# UNITED STATES PATENT AND TRADEMARK OFFICE

AP	PLICATION NO.	FILING DATE	FIRST NAMED INVENTOR	ATTORNEY DOCKET NO.	CONFIRMATION NO.
	10/720,083	11/25/2003	Etsuo Miyoshi	2003-1699A	4944
	513 7590 10/01/2004			EXAMINER	
		H, LIND & PONACI	ROYAL, PAUL		
	2033 K STREET N. W. SUITE 800 WASHINGTON, DC 20006-1021			ART UNIT	PAPER NUMBER
				3611

YC						
7	Application No.	Applicant(s)						
7	10/720,083	MIYOSHI, ETSUO						
Office Action Summary	Examiner	Art Unit						
	Paul Royal	3611						
The MAILING DATE of this communication a Period for Reply	appears on the cover sheet wit	th the correspondence address						
A SHORTENED STATUTORY PERIOD FOR REF THE MAILING DATE OF THIS COMMUNICATION  - Extensions of time may be available under the provisions of 37 CFR after SIX (6) MONTHS from the mailing date of this communication.  - If the period for reply specified above is less than thirty (30) days, a construction of the provision of the provision of the period for reply is specified above, the maximum statutory perion of the period for reply within the set or extended period for reply will, by state that the period for the provision of the period by the Office later than three months after t

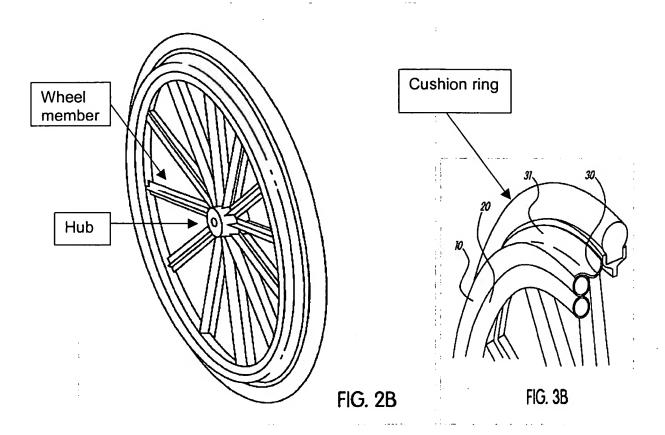
Baldwin et al. teaches a wheel having a rim member (40) forming outer periphery:

a hub member (Hub, see Examiner's annotated Figure 2B) rotatably connectable to a wheel chair part at the center of the rim member via a wheel member (wheel member, see Examiner's annotated Figure 2B);

a rubber cushion ring (cushion ring, see Examiner's annotated Figure 3B) fixed on the outer periphery of the rim member (40);

continuous wall portion (30) on the outer side of the outer periphery;

wherein the continuous wall portion (30) is formed in a ring shape along the rim (20), and provides a grip ring (50) on the edge portion, and

wherein a finger-holding cavity is formed by the continuous wall portion (30), the finger-holding cavity being capable for insertion of user's finger inside to rotate the wheel by gripping the grip ring (50); and

wherein the continuous wall portion (30) is either curved or angled toward the center portion of the wheel, and the grip ring (50) on the edge portion is positioned on the center side from the outer periphery edge of the rim member (20).
